DUGGAN MORRIS ARCHITECTS

job title					
BARTRAM'S HAMPSTEAD					
drawing title/location					
BASEMENT FLOOR PLAN					
status		PLANNING			
scale		1:100@A1	1:200@A3		
job no	source	zone	element	drawing no.	revision
A213	A		(01)	1 01	B

drawing title/location
LOWER GROUND FLOOR PLAN

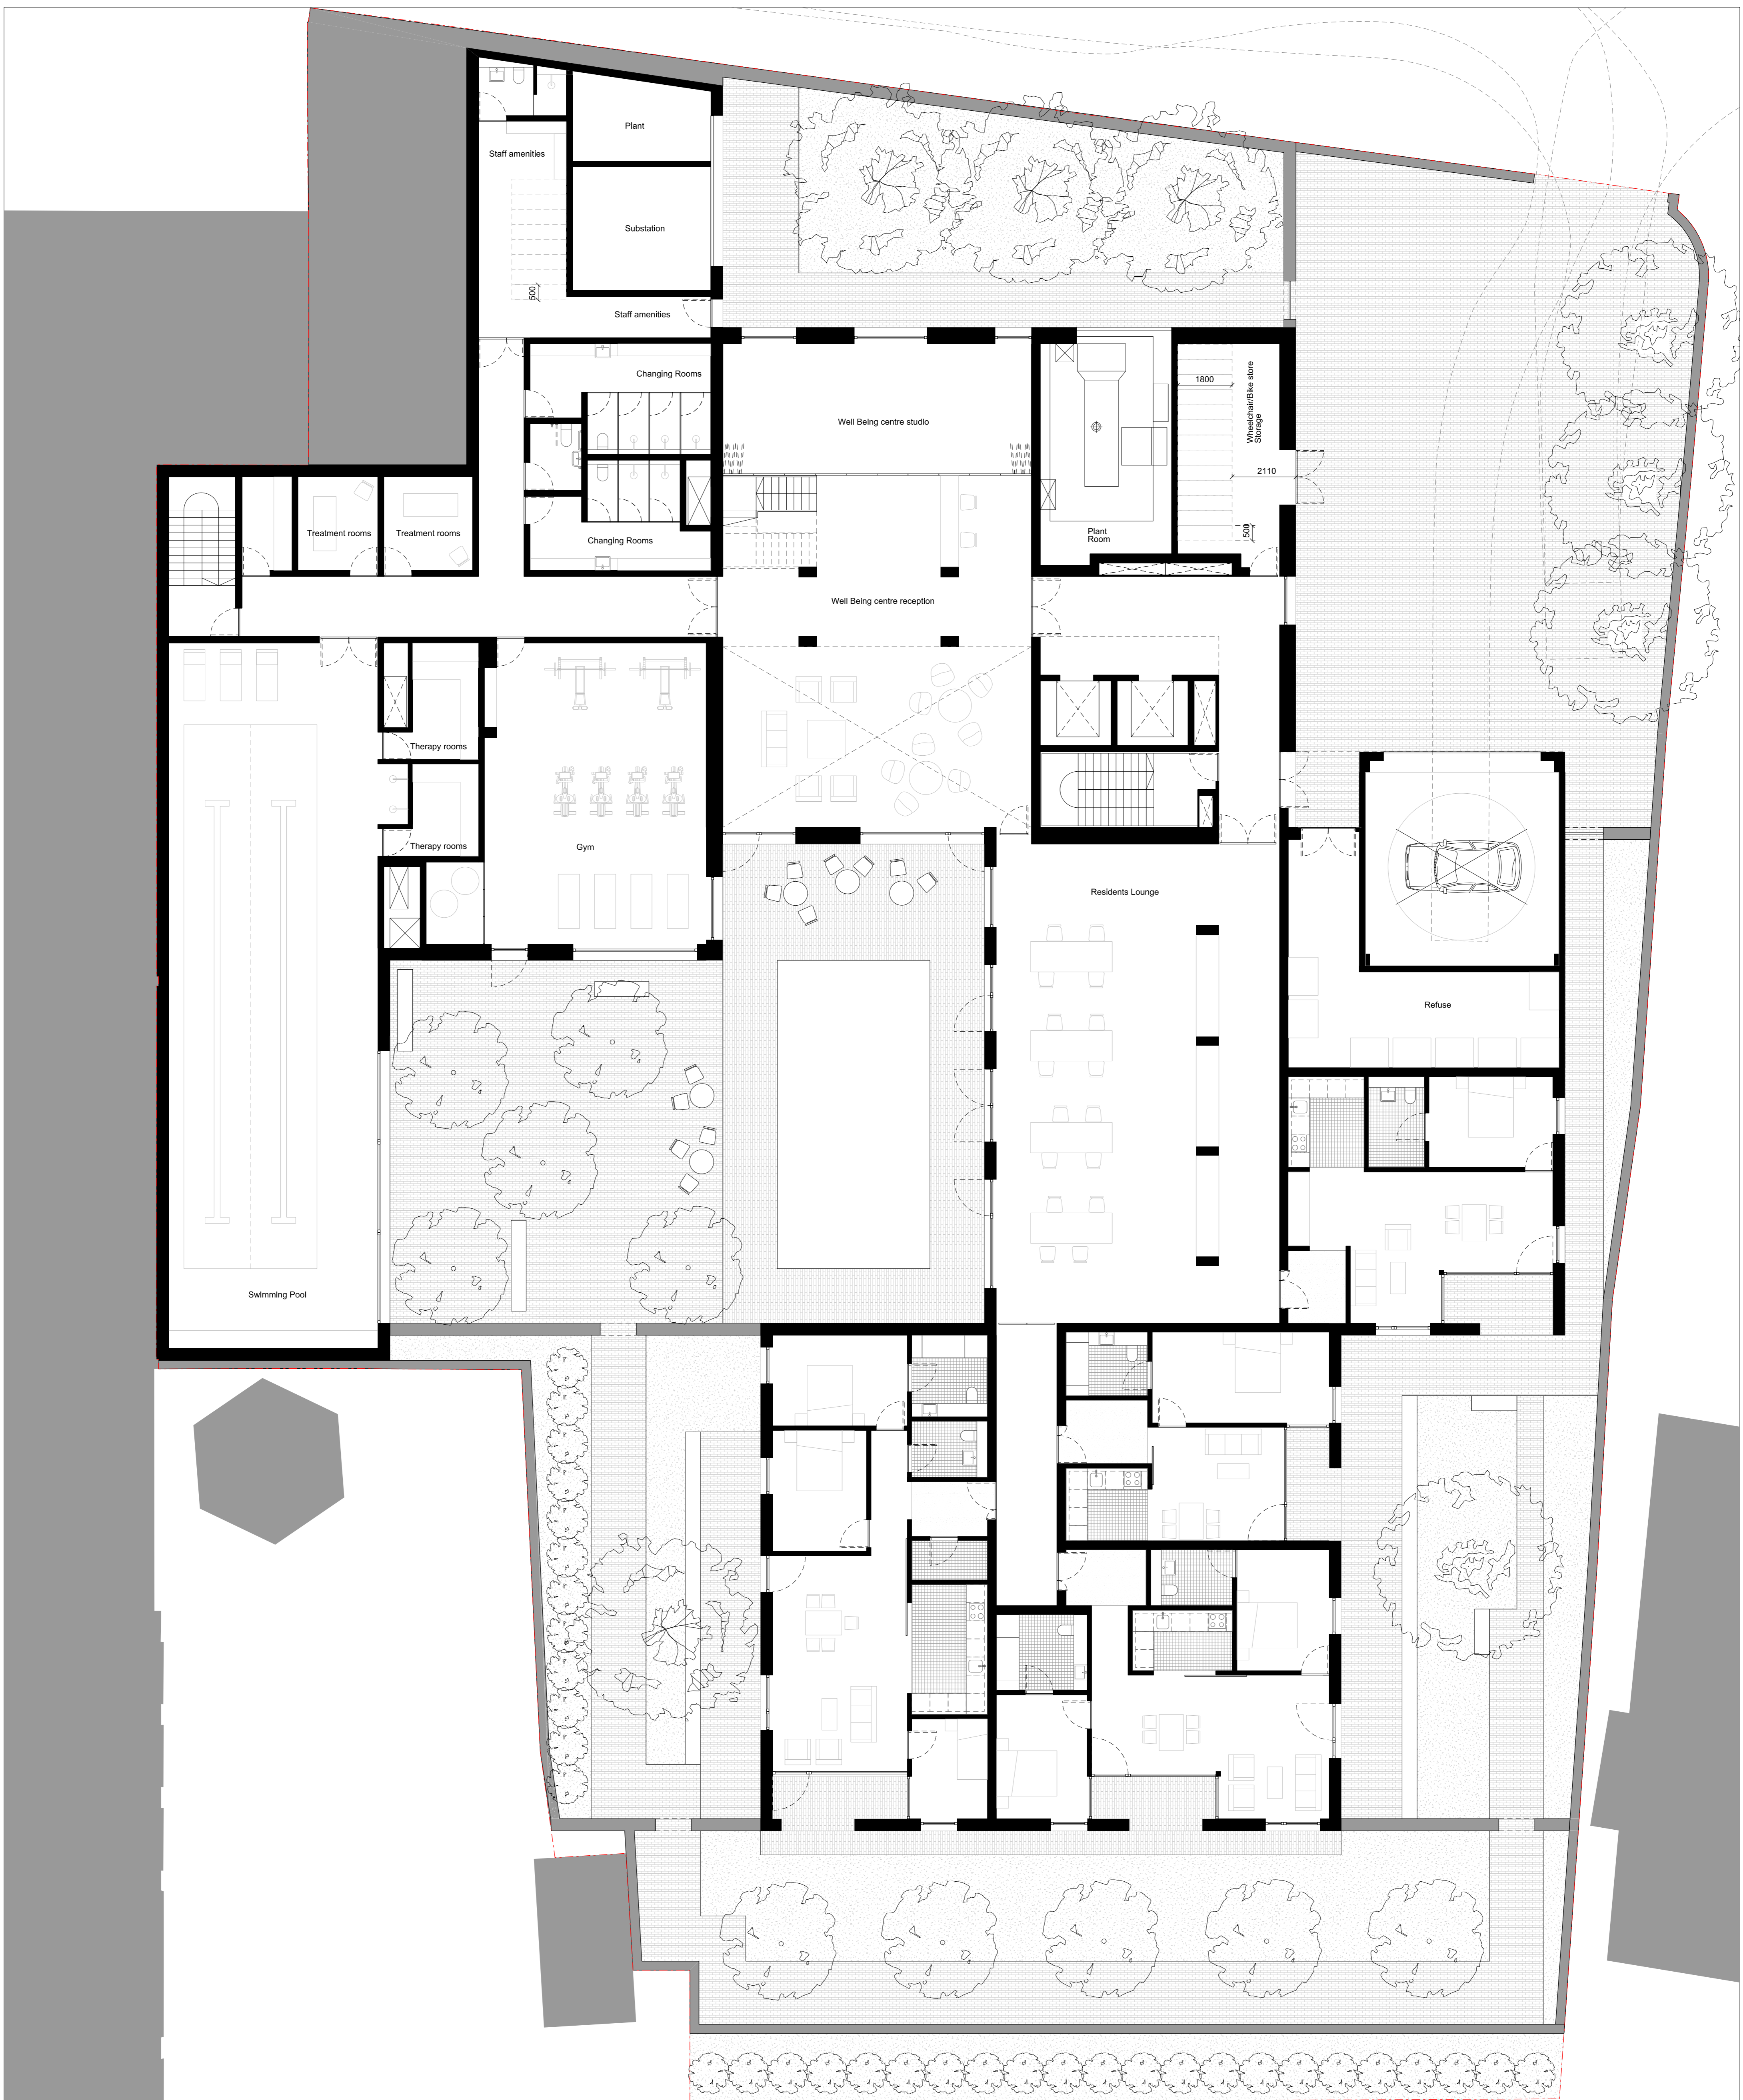
revision	date	amendment
B	10.04.15	Lift car size amended to 1850mm x 1400mm
A	09.03.15	Bike store dims clarifications
/	01.10.14	Submitted to planning

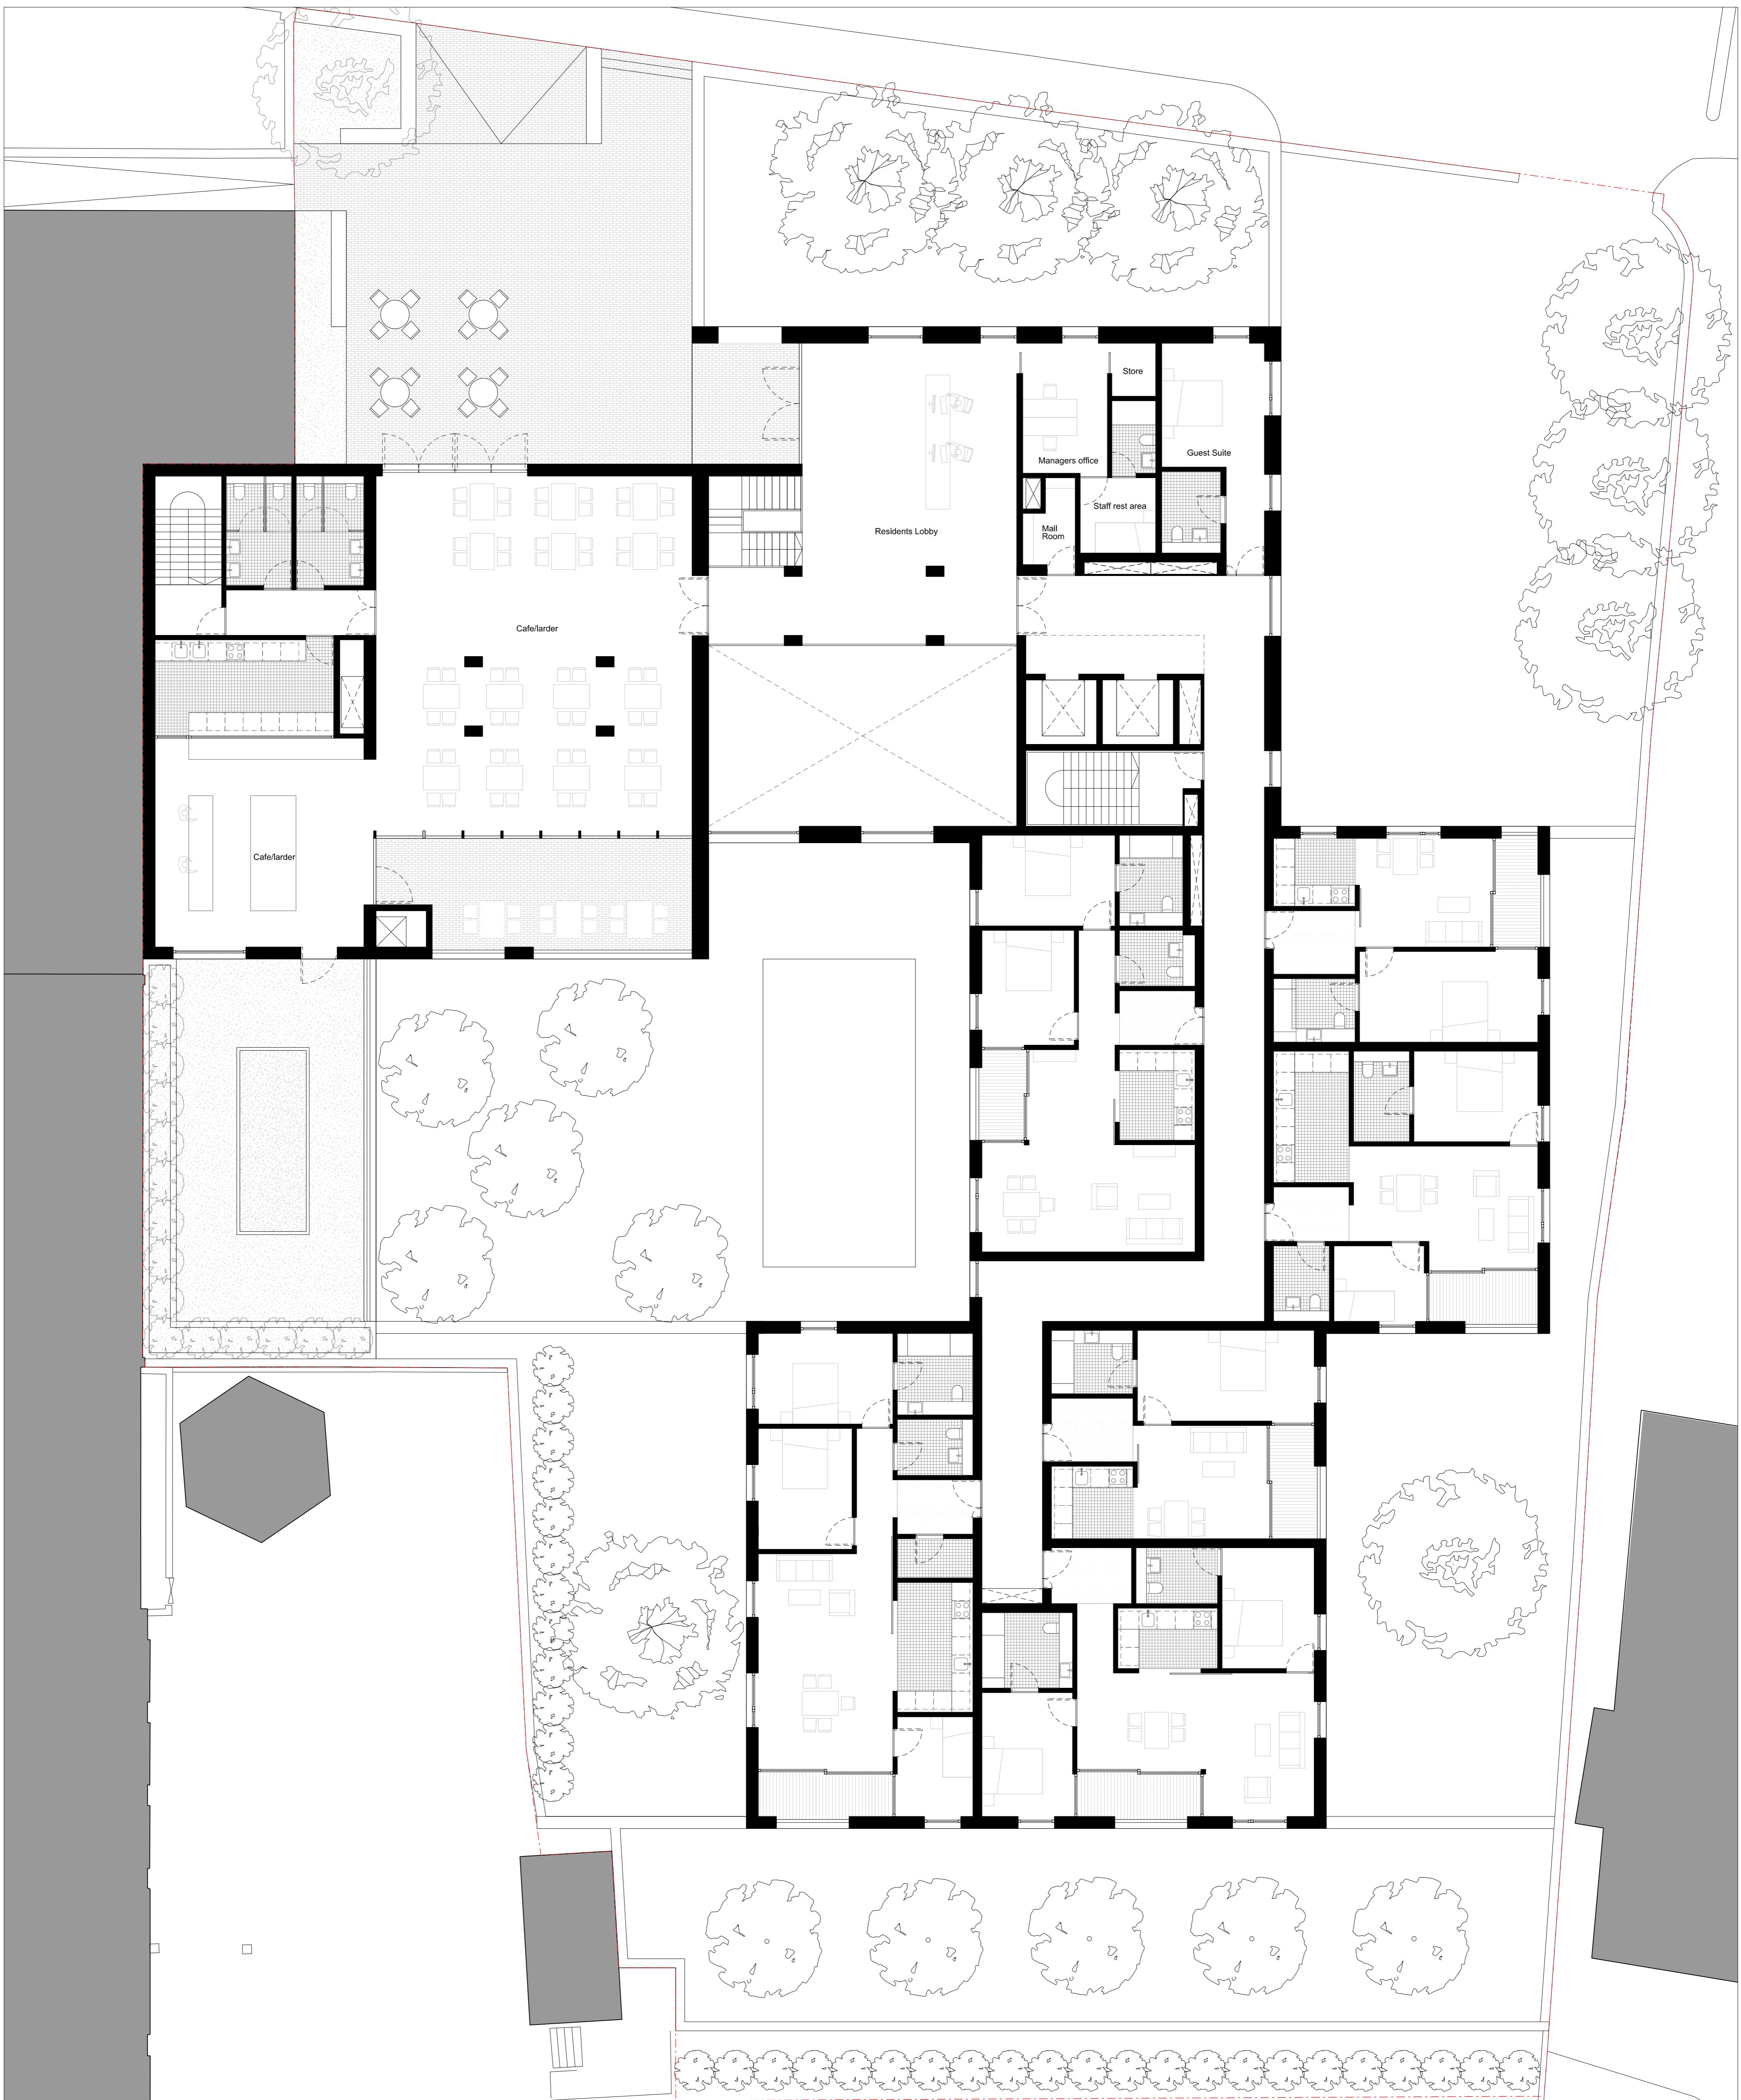
revision	date	amendment
C	10.04.15	Lift car amended to 1850mm x1400mm
B	09.03.15	Cycle rack dims clarifications
A	27.02.15	Cycle racks shown/wheelchair buggies store
/	01.10.14	Submitted to planning

drawing title/location
FIRST FLOOR PLAN

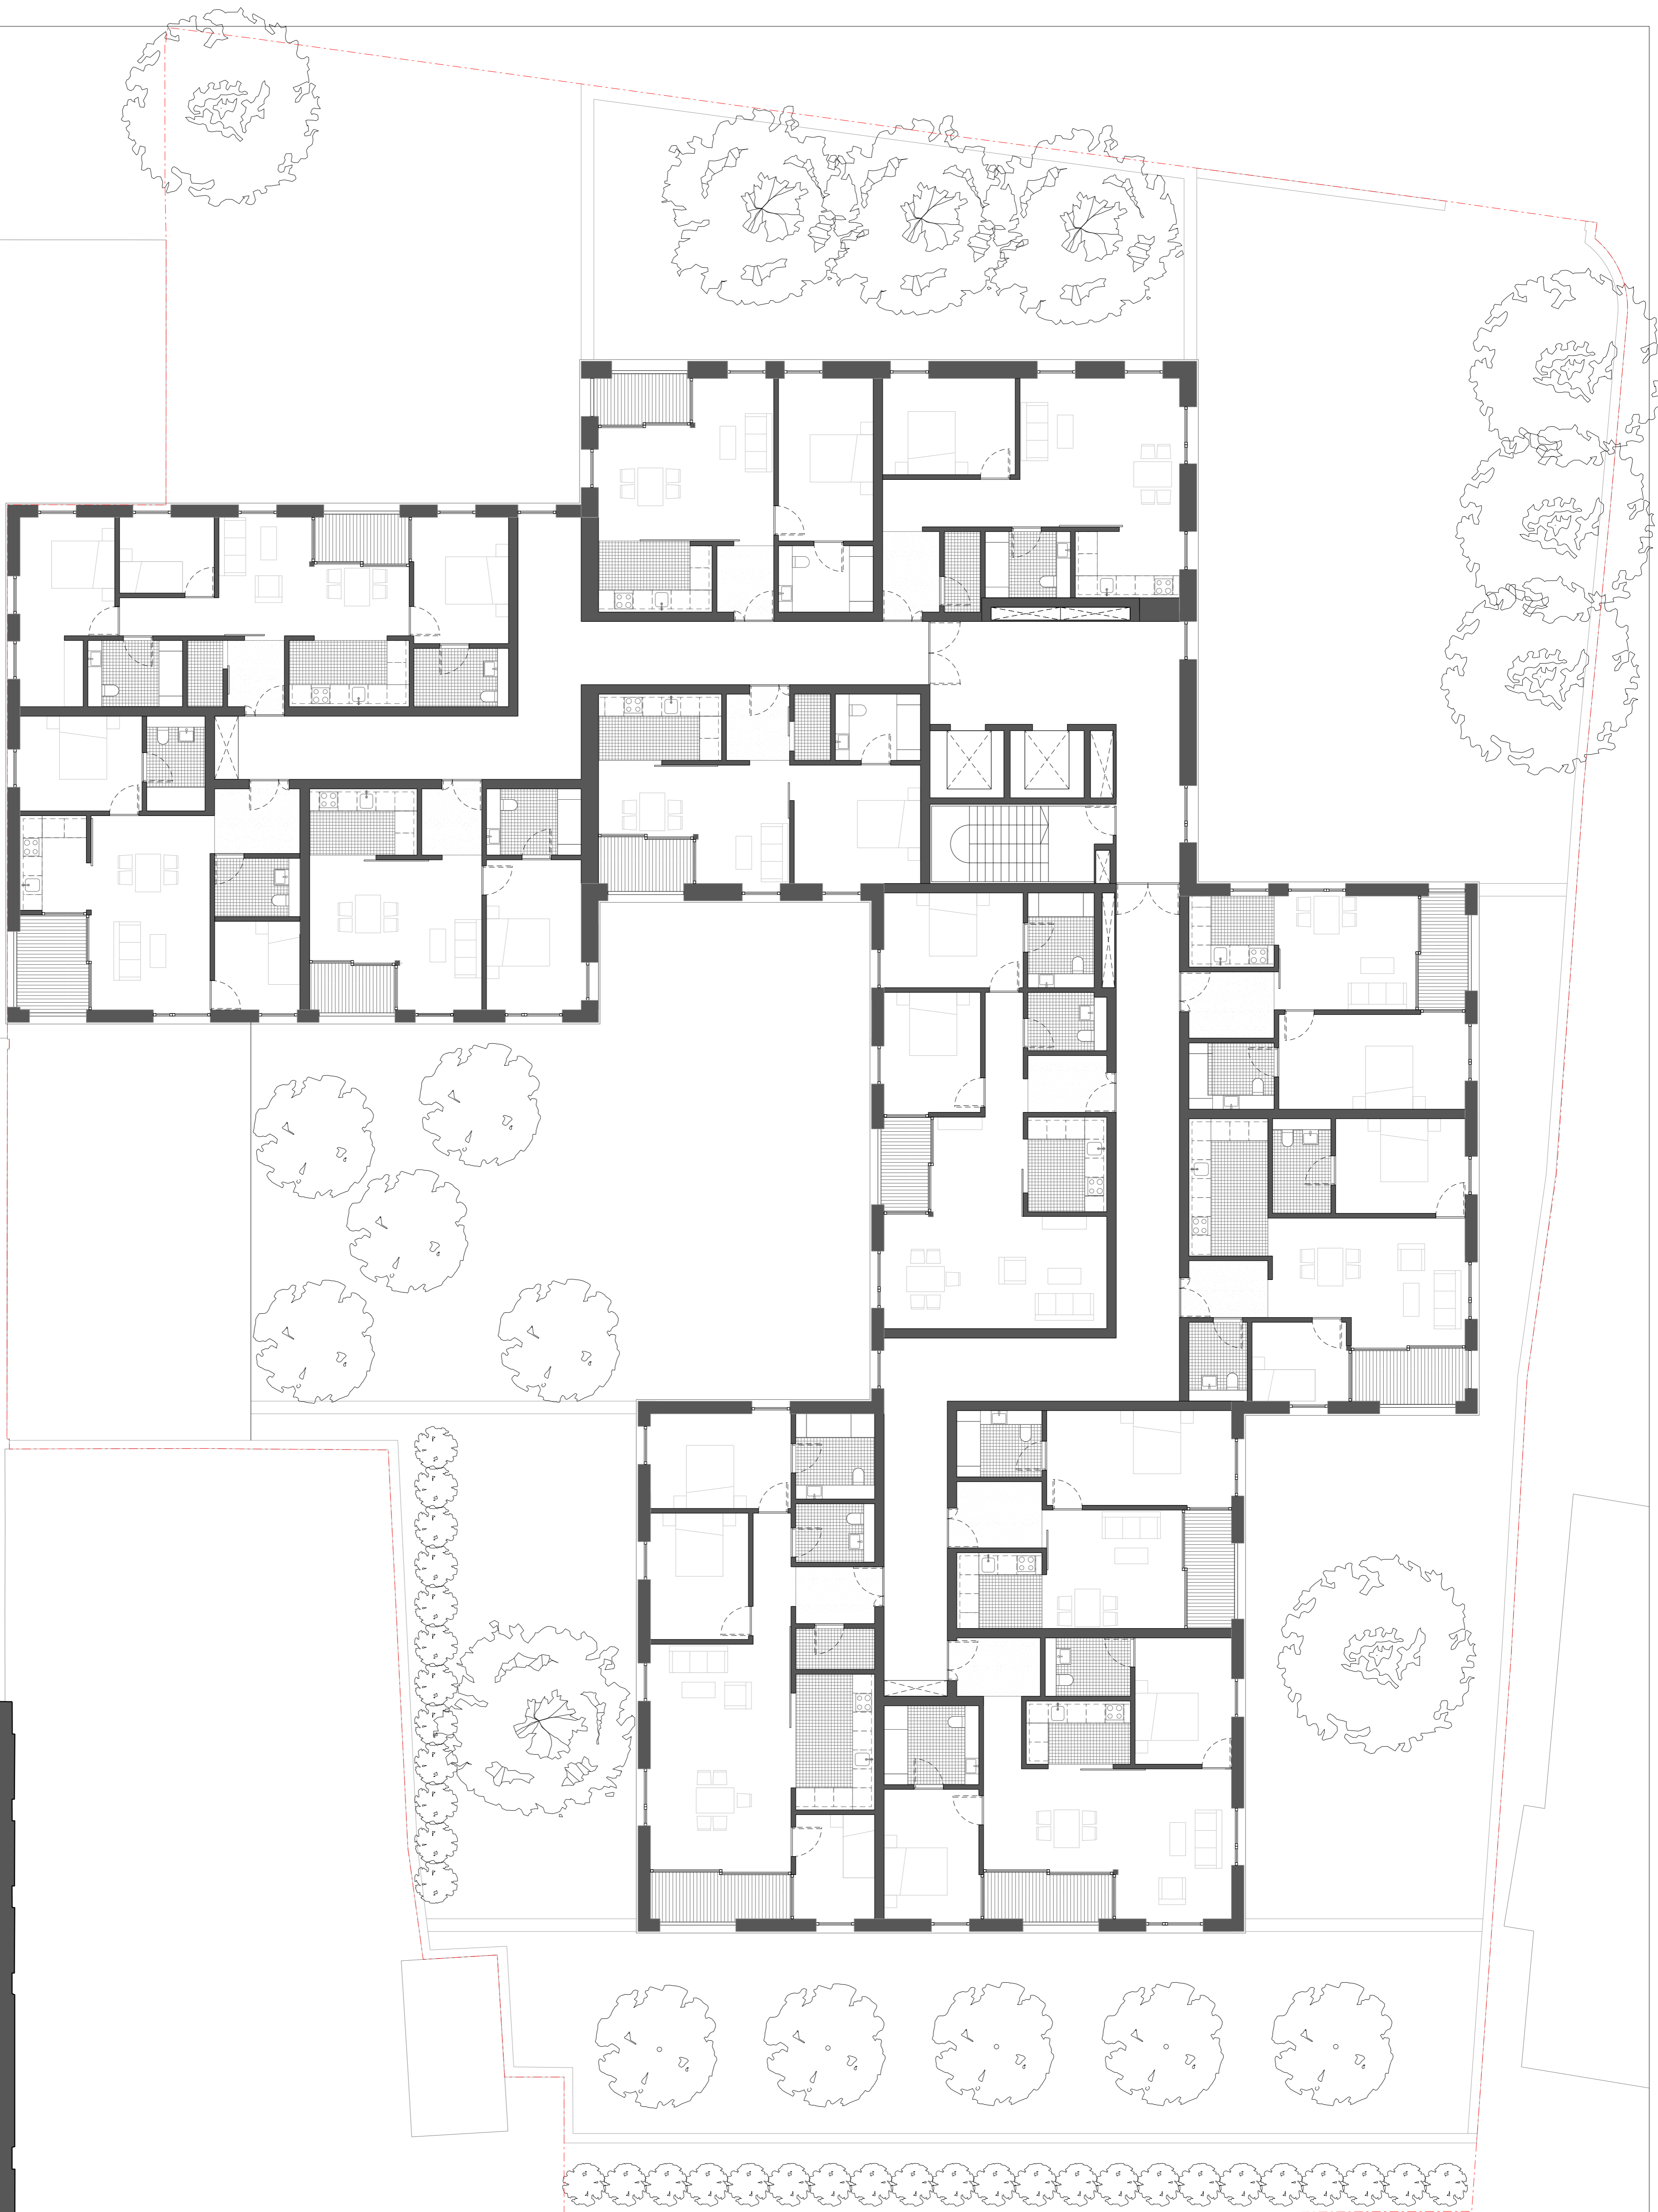
revision	date	amendment
A	10.04.15	Lift car amended to 1850mm x 1400mm
I	01.10.14	Submitted for planning
